June 21, 1996

Refer to: HNG-14

3 Enclosures  
Acceptance Letter CC-35

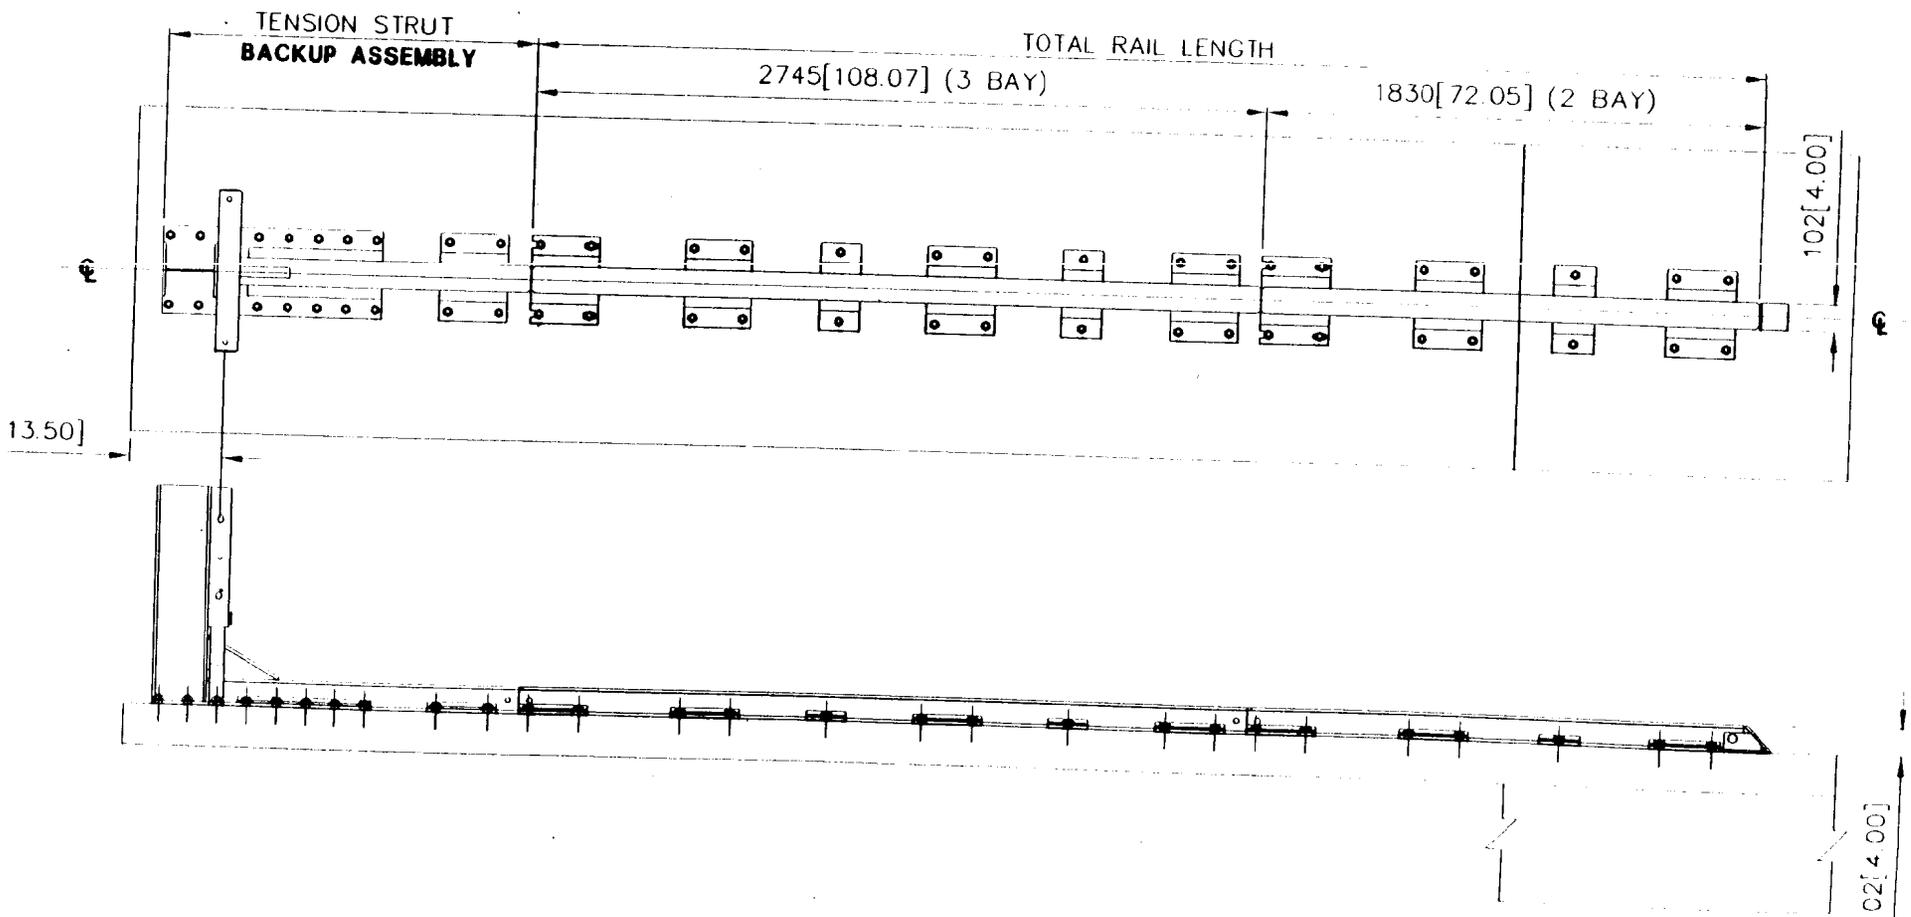
However, since the QuadGuard will be used extensively to shield the ends of median barriers, it becomes critical that the transition design be adequate to prevent vehicles from snagging on the QuadGuard when the barrier is struck in a reverse-direction hit. Your drawings do not detail or dimension the transition designs to the extent that satisfactory performance can be inferred. There is a possibility that the fender panels could snag a vehicle in a wrong-way hit of the concrete barrier transition. Of greater concern is the transition design proposed for the QuadGuard transition to a w-beam median barrier. Because the design deflection of the w-beam median barrier is approximately 600 mm, the likelihood of a vehicle snagging at the transition cap or on the rigid tension strut seems high.

Based on the above, we consider the QuadGuard to be acceptable for use on the National Highway System (NHS) as a TL-3 attenuator *at locations where reverse-directions hits are*

*unlikely* when such use is requested by a highway agency. Once it has been demonstrated through crash testing that the concrete safety shape and w-beam median barrier transitions perform satisfactorily, the QuadGuard can be installed wherever it is deemed appropriate by the using agency. We believe two of the three transition designs you submitted should be tested, the concrete barrier transition and the w-beam median barrier transition. If the w-beam transition test results are satisfactory, we can assume a similar treatment for a thrie-beam median barrier would also be acceptable. Should you have any questions regarding these recommendations or wish to discuss the suggested tests in detail, please call Mr. James Hatton at (202) 366-1329 or Mr. Richard Powers at (202) 366-1320.
